DRAFT MITIGATION PLAN

The John Deere Stream and Wetland Mitigation Site
Rutherford County, North Carolina
Project No. 96917
Contract No. 6402

MEMORANDUM

RE: Response to John Deere Mitigation Plan Comments, Received February 13, 2017
John Deere Draft Mitigation Plan, Project No. 96917, Contract No. 6402

FIGURE 7

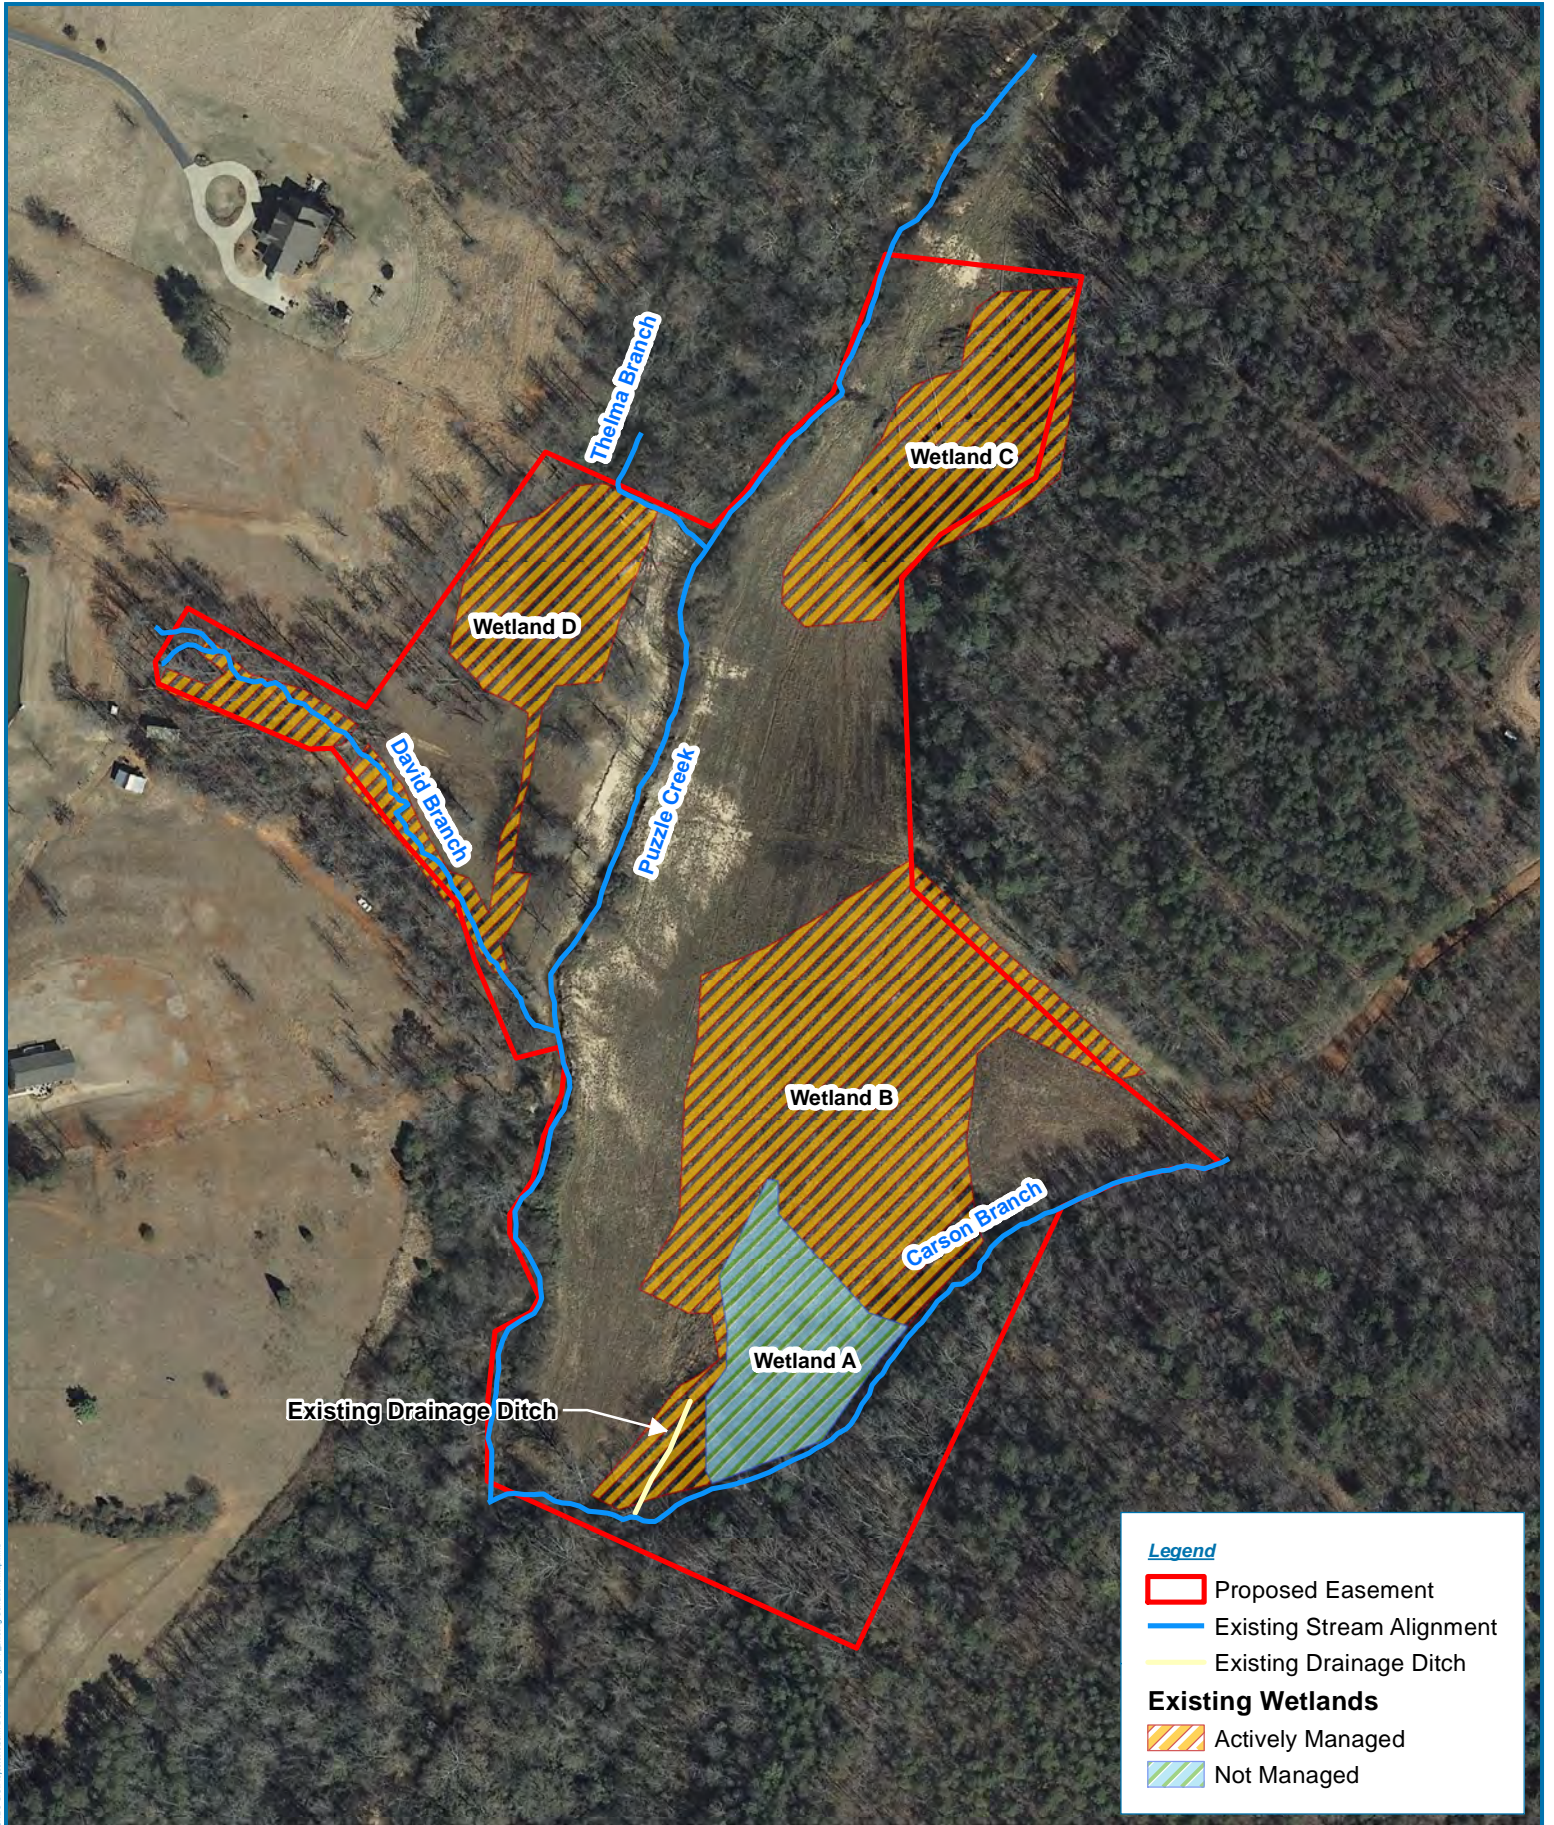
5. Figure 7.0. Characterizing Wetlands A, B, C, D as existing wetlands indicates that they are only eligible for wetland enhancement or wetland rehabilitation.

Figure 7 is the jurisdictional wetland map. It does not coincide with the conceptual design map. Some non-jurisdictional areas are referenced as wetland re-habilitation and some jurisdictional areas are referenced as wetland re-establishment in the Conceptual Design map. Revise as necessary.

The mitigation plan has been revised. Wetland A is proposed for Enhancement and Rehabilitation, Wetlands B and C are proposed for Rehabilitation, and Wetland D is proposed for Enhancement and Rehabilitation. However, wetland mitigation treatments are based on results from the detailed hydric soil investigation, and therefore small areas of jurisdictional wetland overlap into areas proposed for Re-establishment.

Figure 9 - Conceptual Map
John Deere Mitigation Site
 Rutherford County, North Carolina

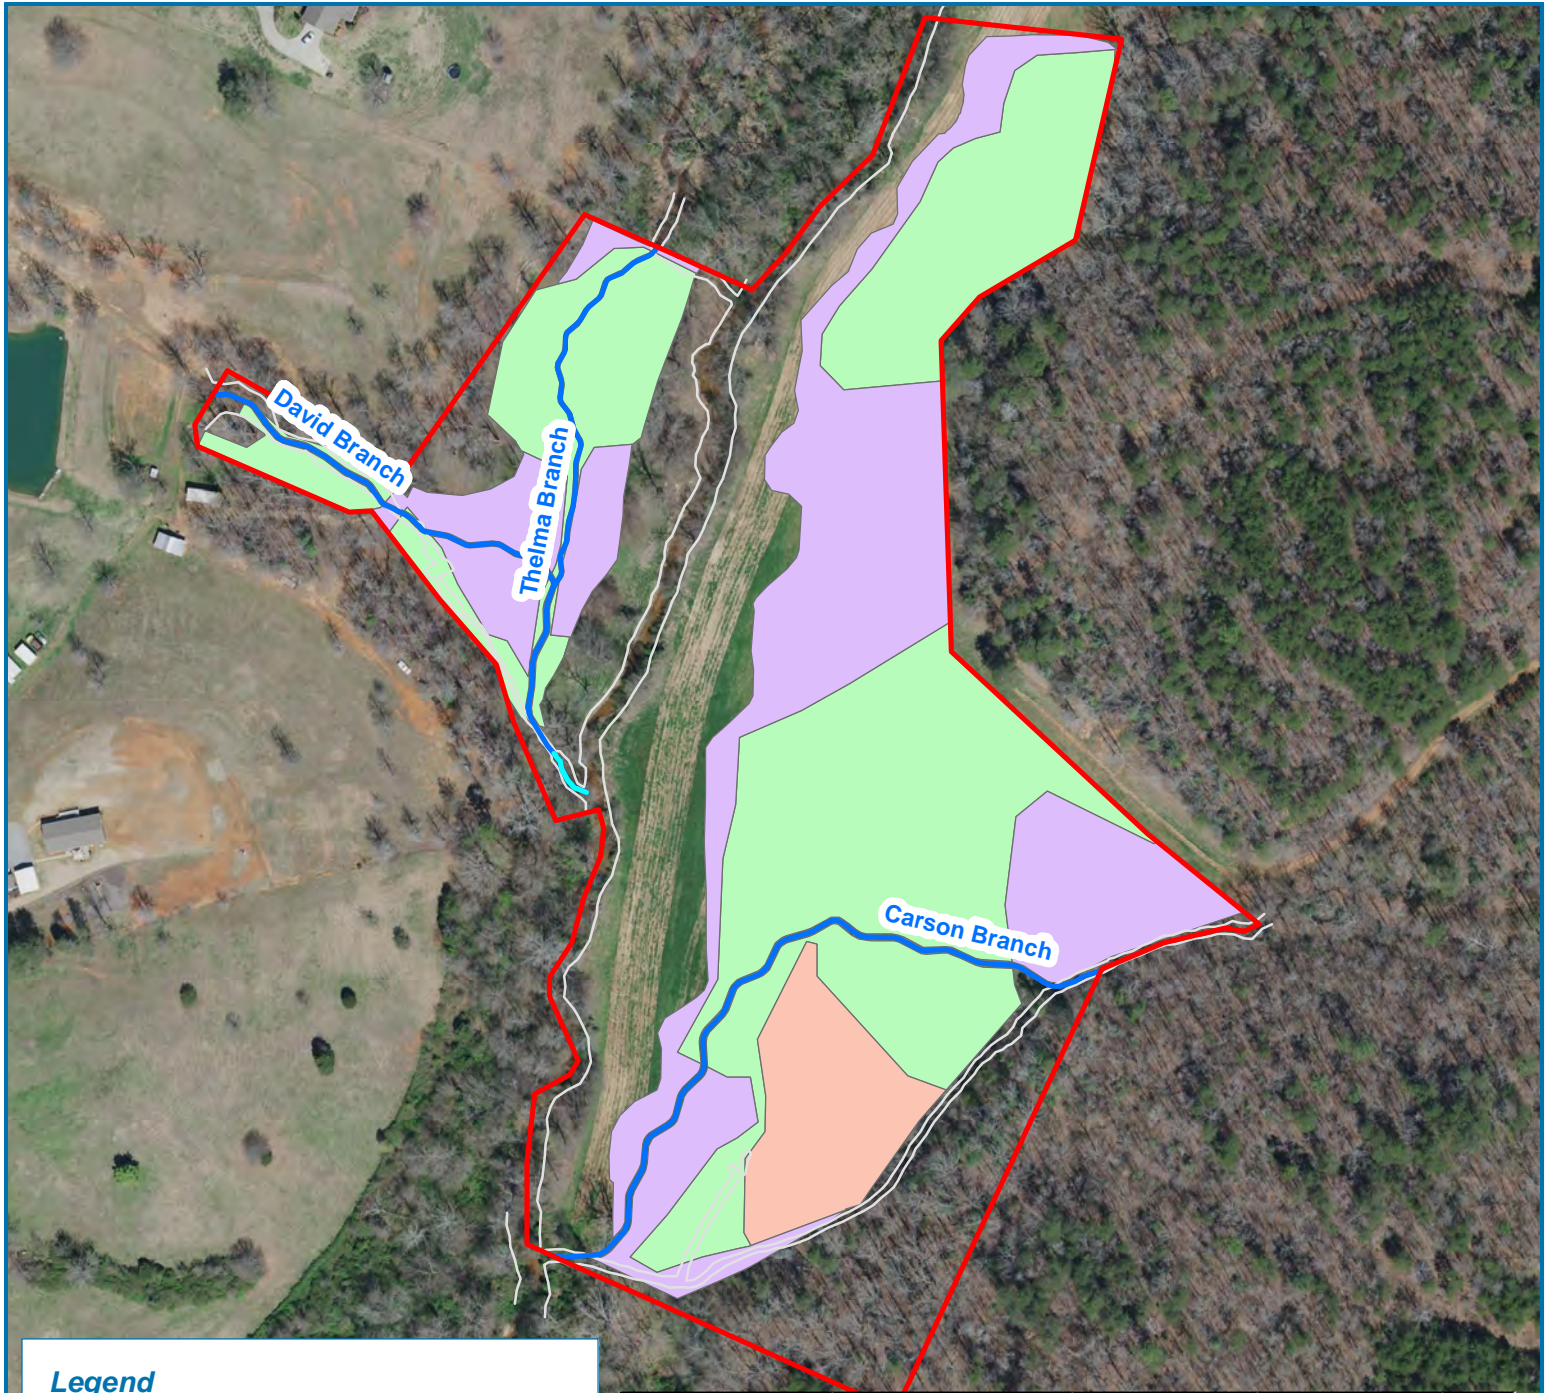
Most of these existing wetland areas are incorrectly identified as wetland re-establishment in the determination of credits and the associated conceptual design map (Figure 9). This needs to be corrected in the revised mitigation plan. If RES proposes a 1:1 mitigation ratio for wetland rehabilitation, the approach needs to clearly justify the ratio based on the level of anticipated intervention and the proposed functional uplift to the aquatic resource. Please keep in mind that separate areas of wetland rehabilitation may not all justify a 1:1 ratio.

3. **Section 6 – Determination of Credits:** The “Reach” and “Mitigation Type” in Table 9 do not correspond with Figure 9. HB1; HB2; and HB3 should correspond with Carson Branch; David Branch; and Thelma Branch. Table 2 indicates an enhancement level II approach on David Branch. Enhancement High and Enhancement Low are not mitigation types. Please QA/QC Table 9 and Figure 9 to confirm that they are correct and synonymous.
Table 8 (previously Table 9) has been updated with the correct information and is synonymous with the rest of the document and Figure 9.
4. **Page 11:** “Project Goals address stressors & will be address through...objectives.”
 - i. Where are your specific and measureable project goals? Text above suggest you have goals, but they are not listed.
Specific and measurable goals are listed above the project objectives. The text states,

Mitigation types and corresponding credits have been re-worked and clarified for the John Deere Mitigation Plan based on conclusions from the hydric soil investigation, existing jurisdictional wetlands, and levels of land management. Re-establishment is proposed for entire area of floodplain that consists of buried hydric soils and active management (3.66 ac.), and the credit ratio is 1:1. Also,

Rehabilitation area has been changed to include most of the jurisdictional wetland area that is “actively managed” and considered hydric soil based on the hydric soil investigation (5.34 ac.), and the credit ratio has been adjusted to 1.25:1. In addition, jurisdictional wetland areas that are currently undisturbed (0.69 ac.) have been changed to enhancement at a 2:1 credit ratio. All text, tables, and figures have been revised accordingly.
